**Change Request**

**Number:** 44  
**Date:** 2/14/20  
**Job:** 19050 Bonner Springs Govt Services  
**Phone:**

**Description:** RFI 75 & 122 Additional Wood Framing

**Subject:** City Hall: Floor Loading Support Details @ New Mechanical Chase

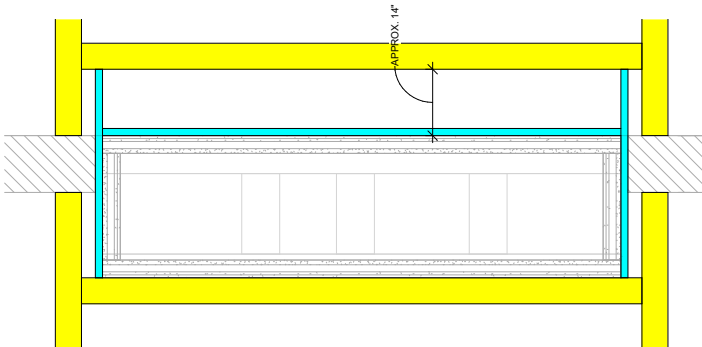
At the locations of the mechanical chases vertical through the building at main corridor we have provided new LVL and PSL construction to carry necessary loads created by a portion of existing masonry removed for mechanical chases. The connection types, existing construction, and bearing needs dictated that the new structural systems built must be oversized to perform required work. It seems these openings should be framed back down to the required size for shaft wall system to pass through without a significant gap (14"+/-) . Assumably a system of dimensional lumber and joist hangers. Please advise.

Provide new 2x12 framing as shown in blue below. New framing needs to be clear of new shaft wall to allow wall to be continuous.  
 -Ryan Hagedorn / BDC / 11-2-19
